ORIGINATION FORM

Proposed Revisions to a Standard Plans Index
(Please provide all information — Incomplete forms will be returned)

Index Number: 450-010

Index Title: Florida I Beam - Typical Details and Notes

INDEX
450-010

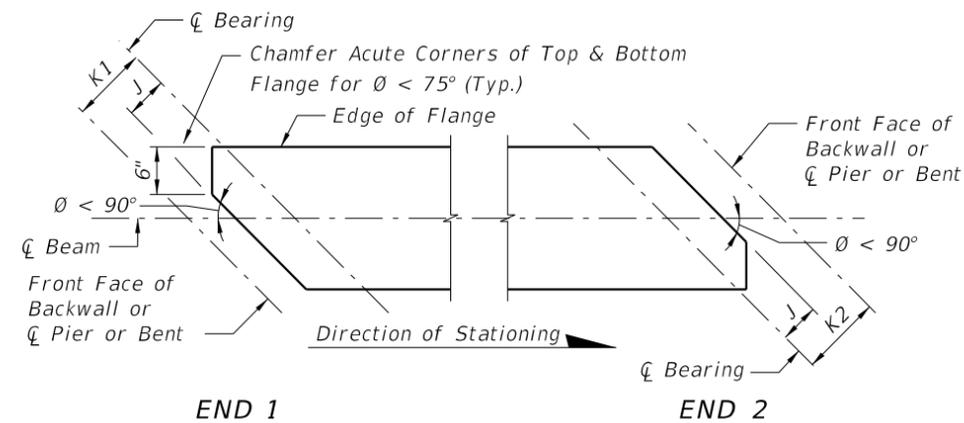
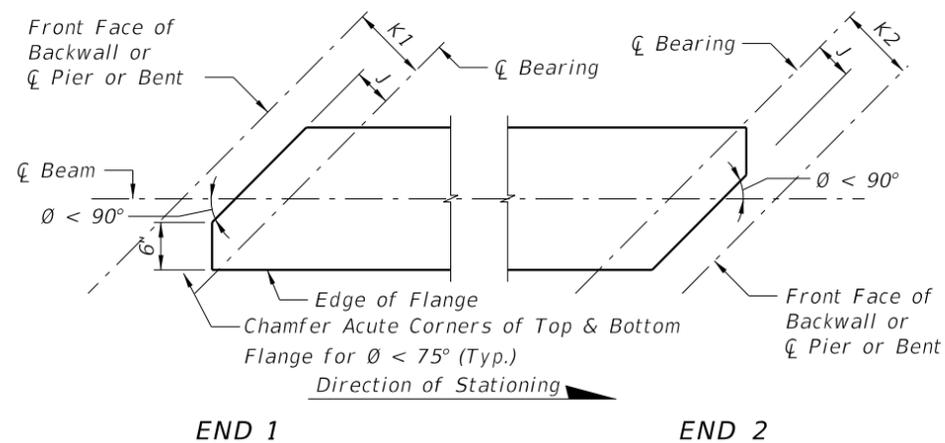
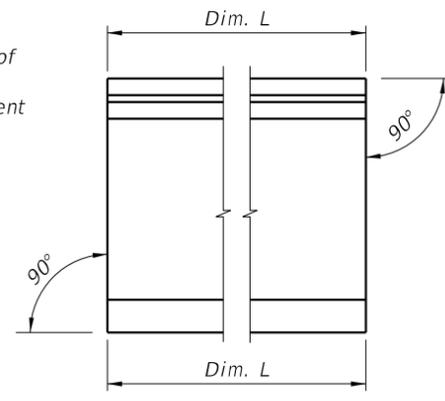
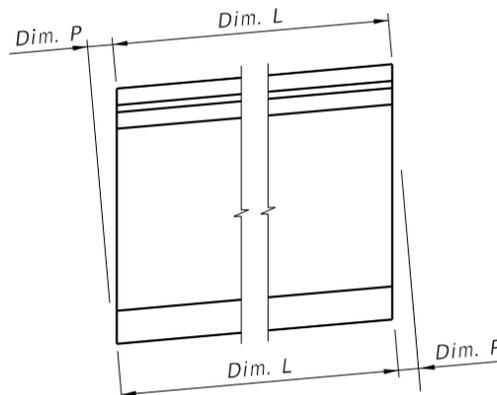
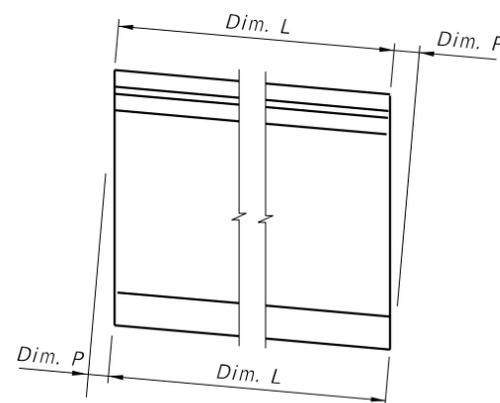
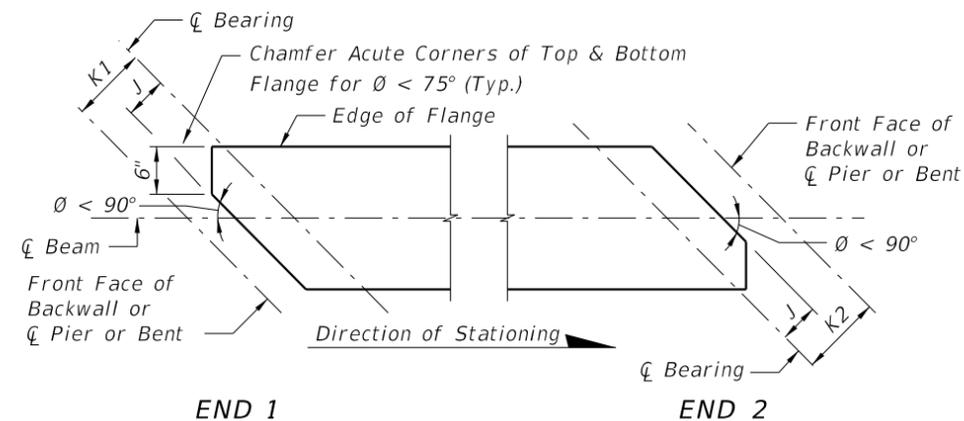
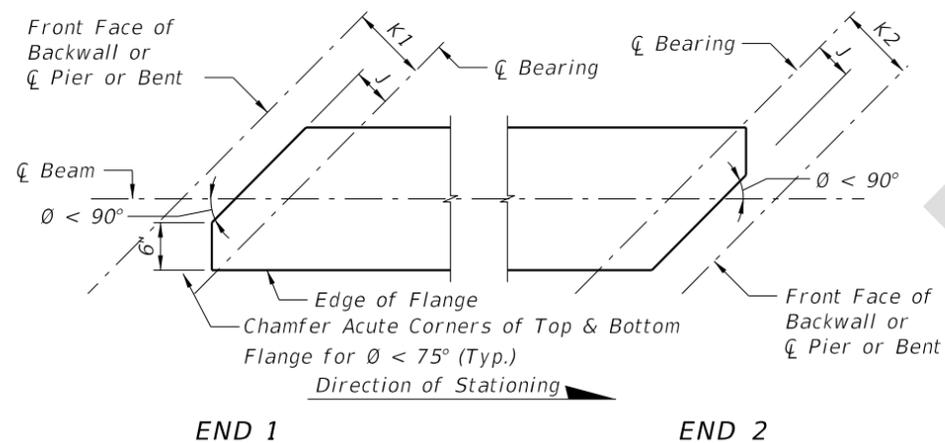
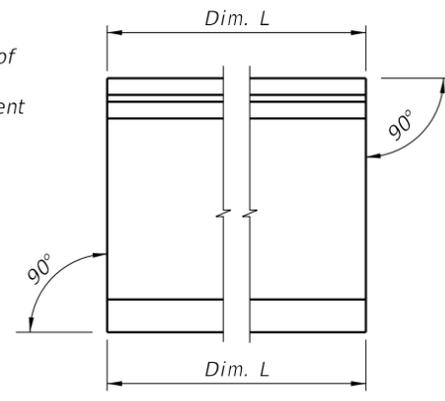
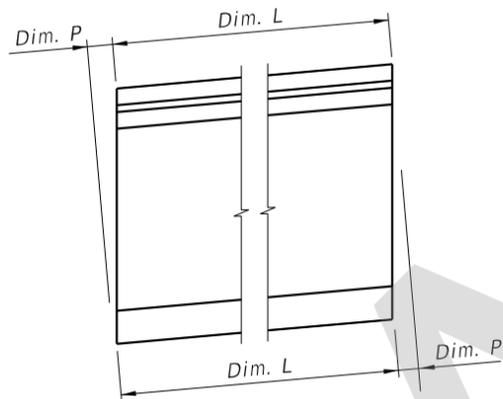
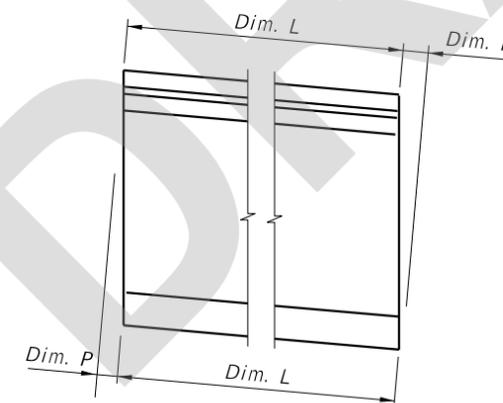
Updated language concerning N type strands in the notes for clarity.

3. Concrete cover: 2 inches minimum.
4. ~~Strands N: 3/8" diameter, stressed to 10,000 lbs. each.~~ **Stress Strands N**
5. Place one (1) Bar 5K or 5Z at each location. Alternate the direction of the ends for each bar (see "ELEVATION AT END OF BEAM" in Standard Details).

- Concrete cover: 2 inches minimum.
- Stress Strands N to 10,000 lbs. each.
- Place one (1) Bar 5K or 5Z at each location. Alternate the direction of the ends for each bar (see "ELEVATION AT END OF BEAM" in Standard Details).
